Executive Director's Recommendation

Commission Meeting: October 4, 2012

PROJECT New Commissary Fort Belvoir, North Post Fairfax County, Virginia	NCPC FILE NUMBER 7150
SUBMITTED BY United States Department of Defense Department of the Army	NCPC MAP FILE NUMBER 2204.00(38.00)43608
REVIEW AUTHORITY Advisory per 40 U.S.C. § 8722(b)(1)	APPLICANT'S REQUEST Preliminary approval of site and building plans
	PROPOSED ACTION Approve building with comments Defer approval of site
	ACTION ITEM TYPE Staff Presentation

Figure 9: Commissary Site Plan

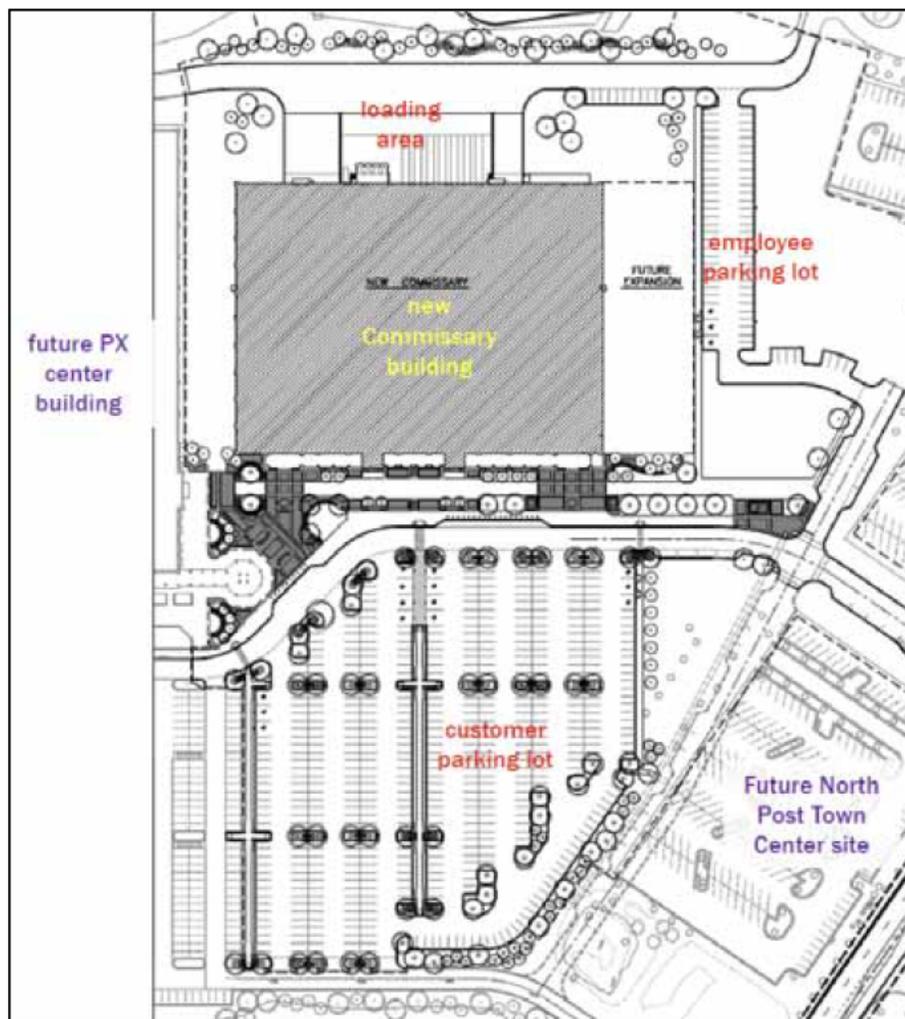
- **The elimination of a separate employee parking lot**

NCPC staff notes that the site plan shows 66 employee spaces, which equates to a 1:1.3 ratio (7 spaces too many) using the assumption that part-time workers utilize their spaces for ½ the time of full-time employees. As such, the 53 part-time employees only require 27 spaces to satisfy their parking demand, rather than the 36 spaces that would be allowable for full-time employees using the 1:1.5 ratio. Thus, the Comprehensive Plan ratio will allow a total of 59 employee parking spaces for the project based on the future full-time and part-time employee population.

Figure 13: Future Tree Clearing Areas

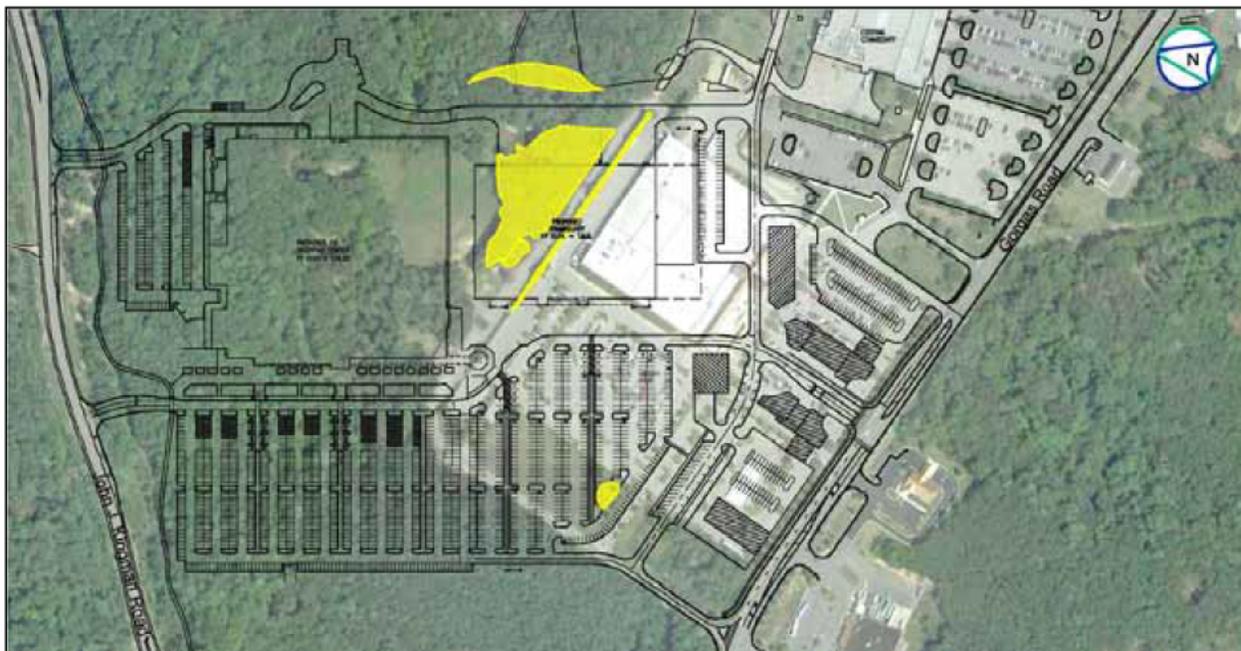
has yet to receive this information. In addition, due to the previous PX center project's removal of trees and the current proposal's plan to remove an additional 3.3 acres of trees, the Commissary's stormwater management design is critical to mitigate this largest environmental impact. As such, although the project submission states that the completed design will comply with a number of different standards (EISA, Section 438; Commonwealth of Virginia; Fairfax County; and Chesapeake Bay Protection and Restoration Act), staff nevertheless recommends deferral of site plan approval until the design is more fully developed and detailed quantitative data is provided to NCPC that demonstrates compliance with these standards.
